MIL-R-83516A(USAF)
 AMENDMENT 3
 23 FEBRUARY 1984
~~SUPERSEDING~~
 AMENDMENT 2
 28 September 1983

RELAYS, REED, DRY, GENERAL SPECIFICATION FOR

This amendment forms a part of Military Specification MIL-R-83516A(USAF), dated 3 March 1983, and is approved for use by the Department of the Air Force and is available for use by all Departments and Agencies of the Department of Defense.

FIGURE 1. Typical circuit for operate and release time and contact bounce with typical traces.

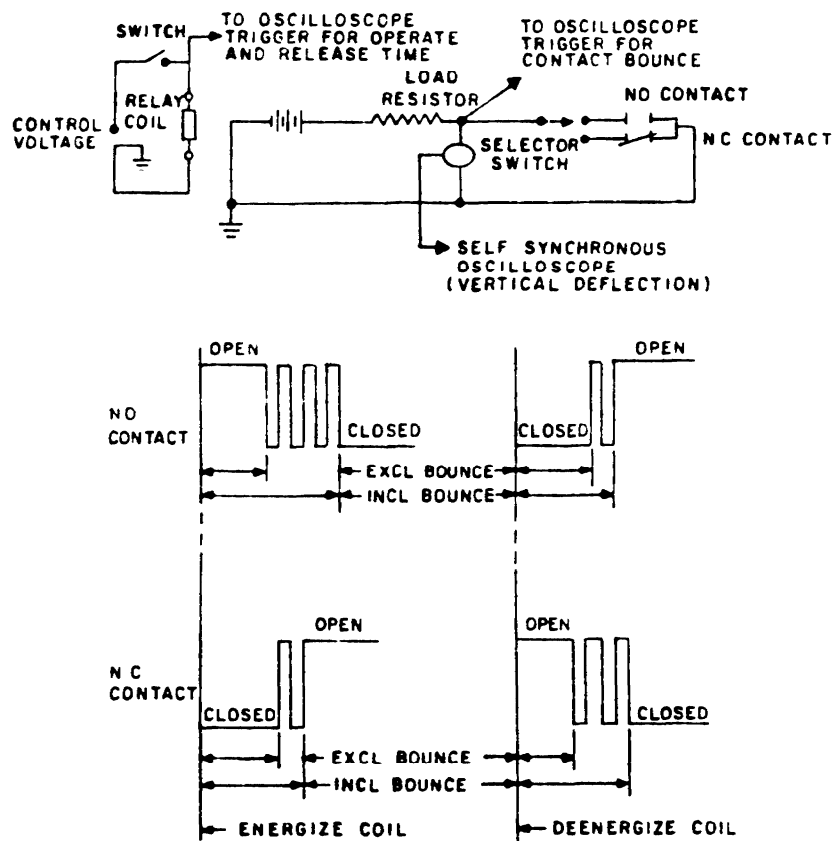
FIGURE 1: Delete and substitute new figure 1 as printed on page 2 of this amendment.
